ADDENDUM #2

FROM : ARCHITECTNICA
555 W. BENJAMIN HOLT DRIVE
SUITE 423
STOCKTON, CA 95207
(209) 952-5850 FAX (209) 952-2442

PROJECT: Bridge Classroom Portable at Beckman ES
Lodi Unified School District

DATE : August 25, 2026

- Revised AA2.0 – Unit J Restroom Floor Plans
- Revised AA2.02 – Unit J Restroom Interior Elevations – Proposed
- Revised AA8.1 – Door, Hardware, & Finish Schedule
- Spec Section 07 46 23 Wood Siding
- Exhibit – Beckman Low Voltage template

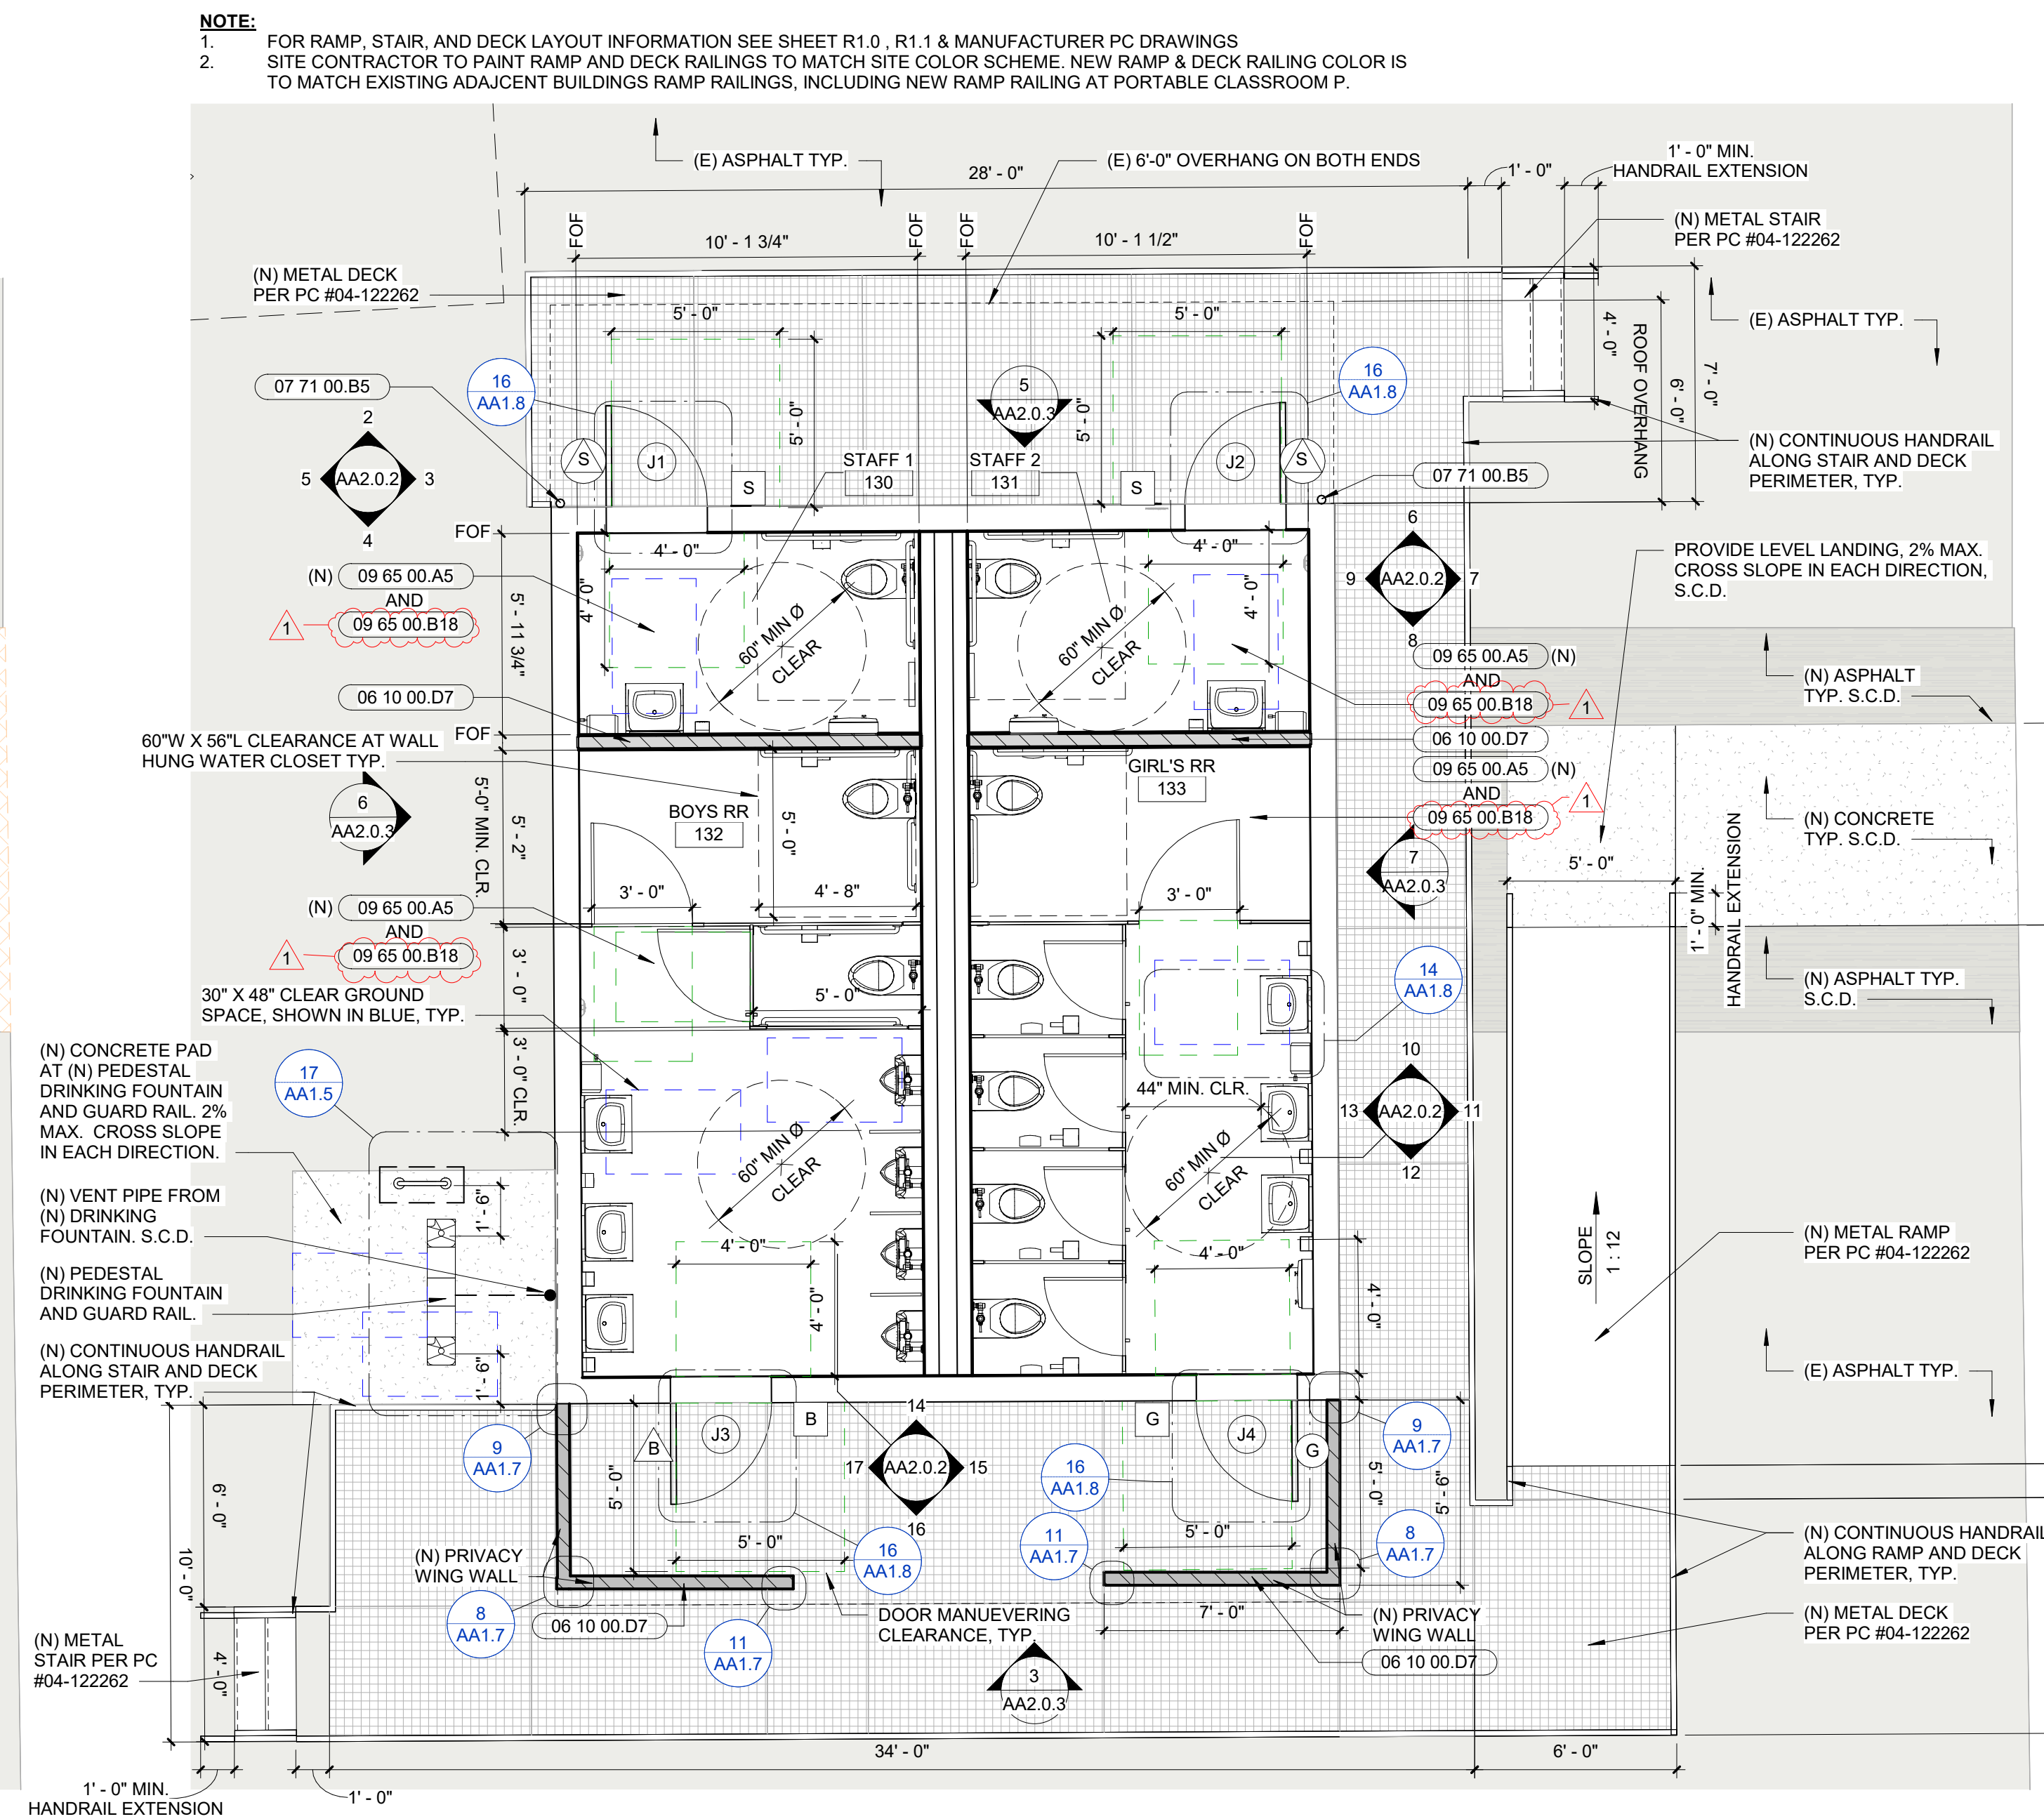
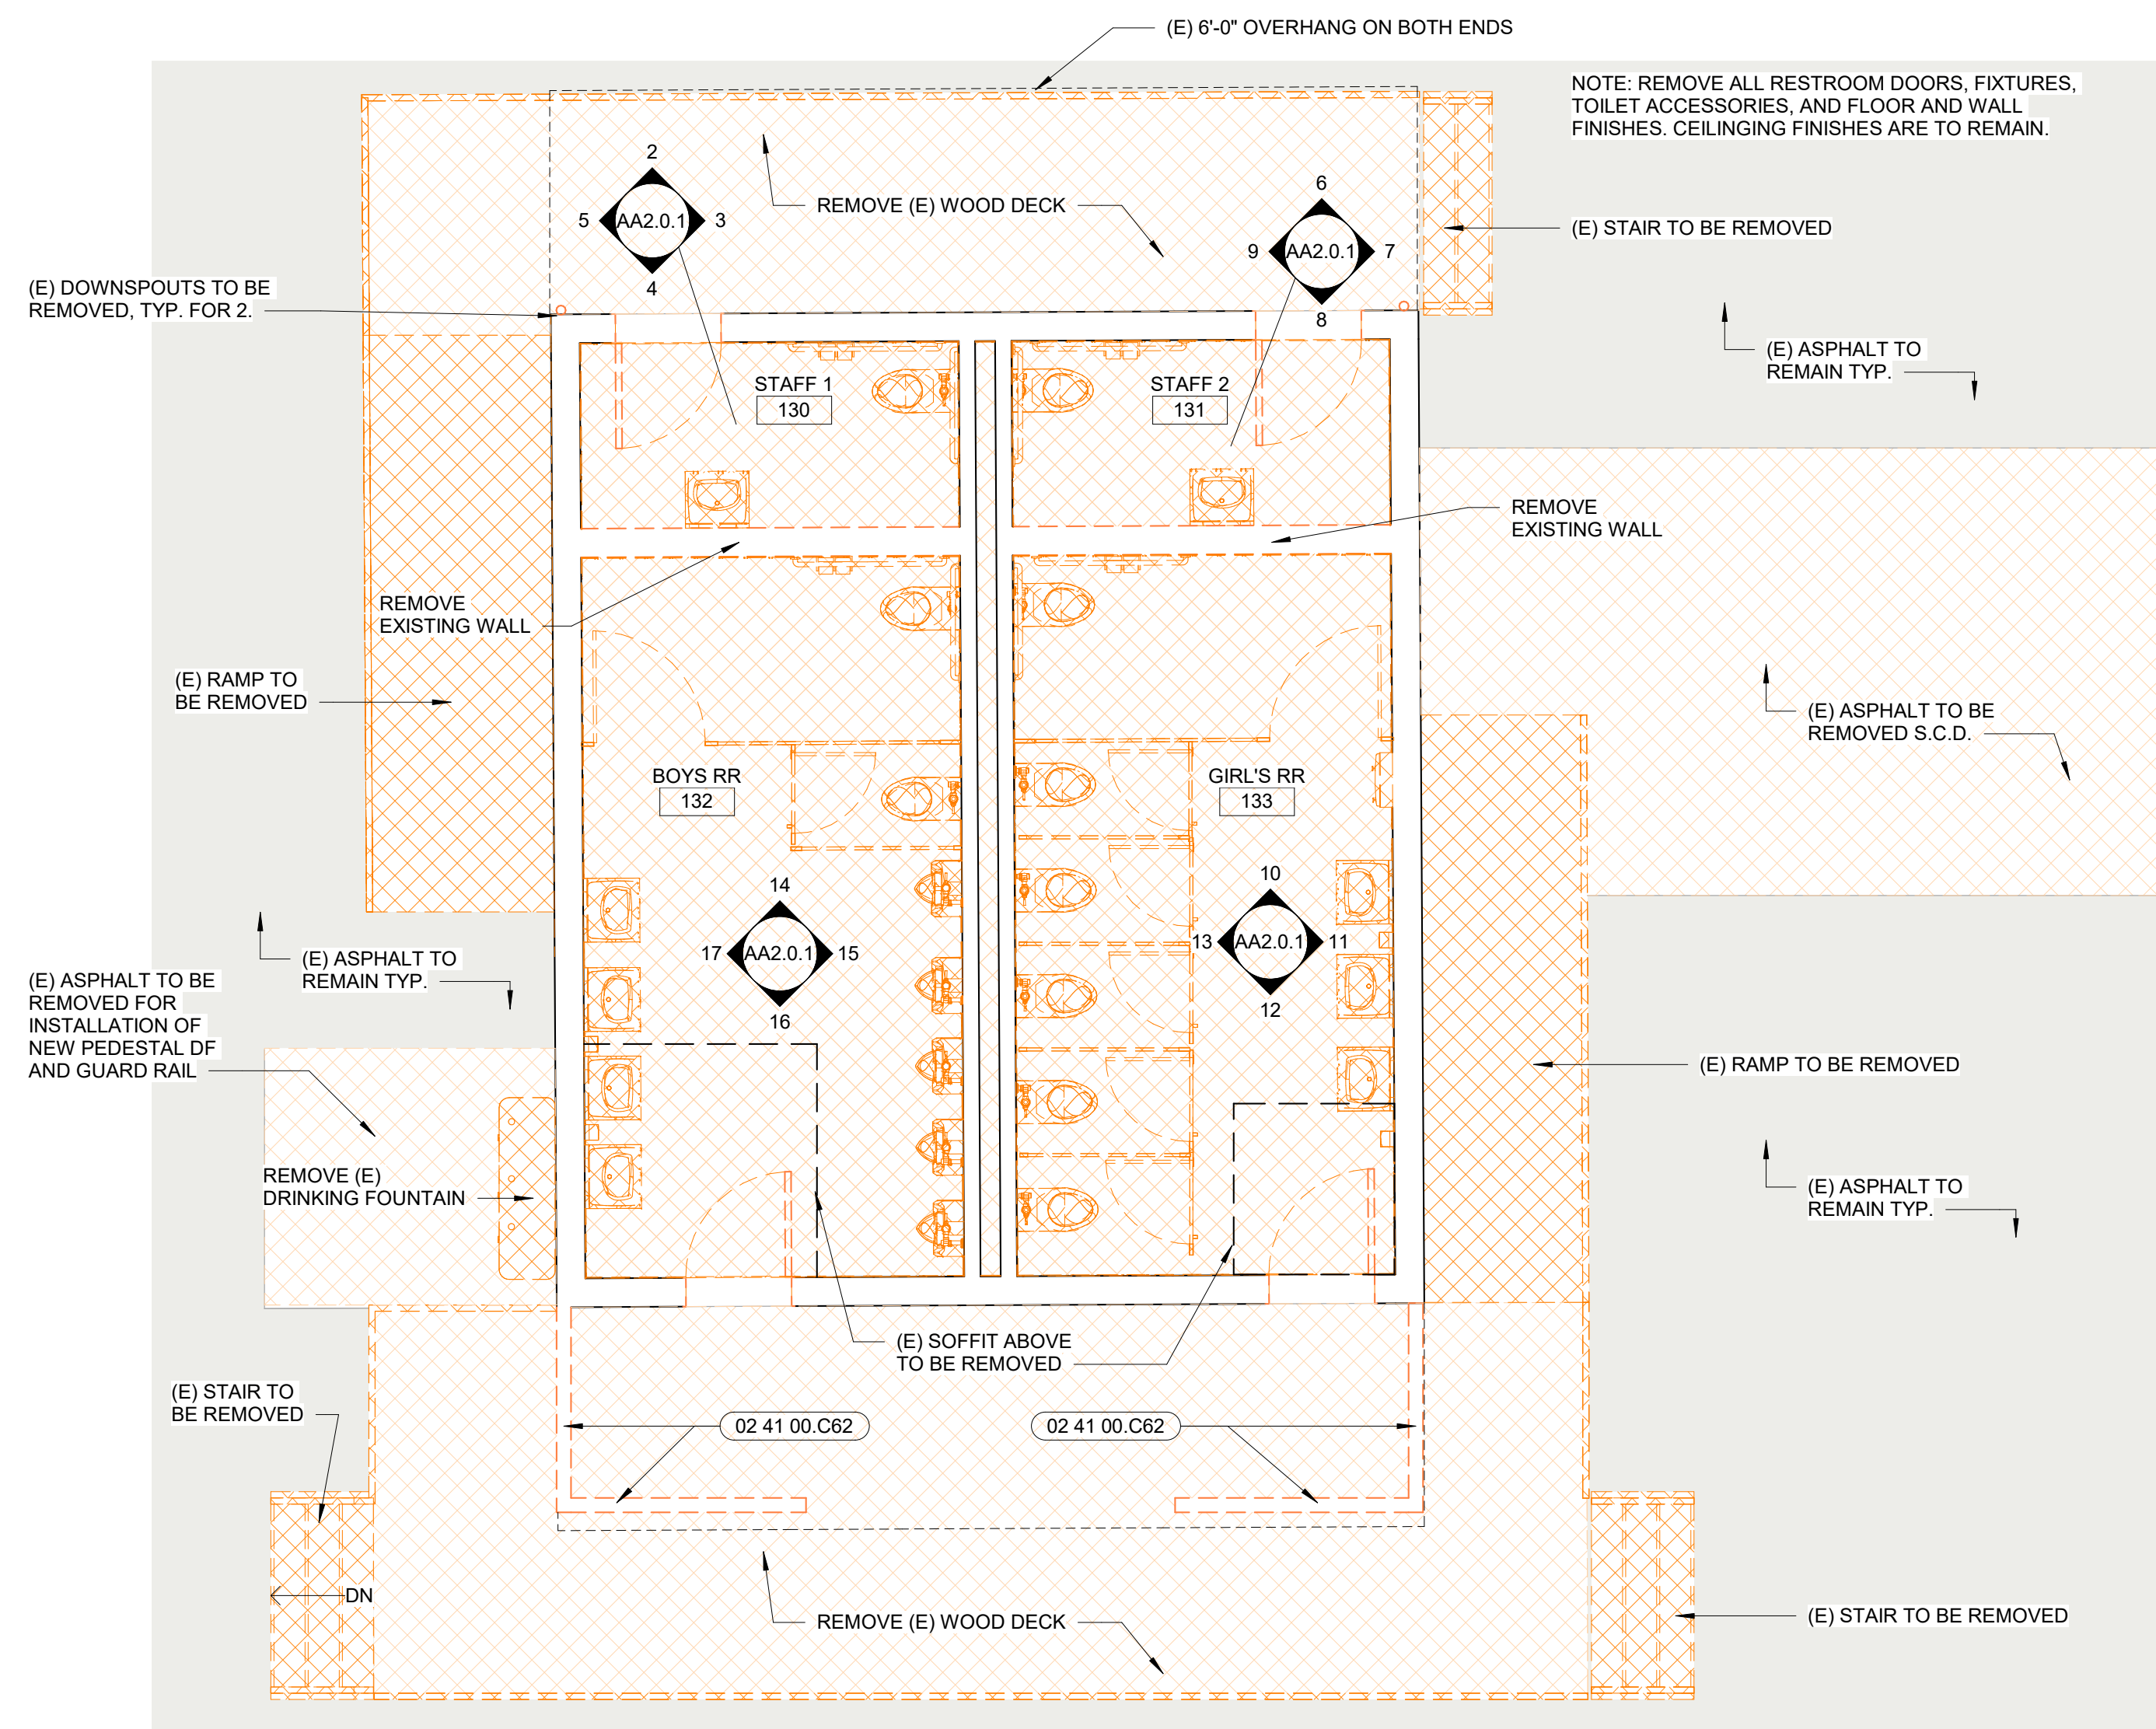
- Per keynote spec 09 65 00 A13 and B22 on page AA2.2, there is to be epoxy base and precast cove base. Is the bathroom floor also epoxy and if so, please provide the correct specifications for the items listed.

A: There will be no epoxy flooring or epoxy base in this project. The staff restrooms and the student restrooms will be sheet vinyl flooring with 6" high sheet vinyl coved base. Drawings have been updated to reflect this change.
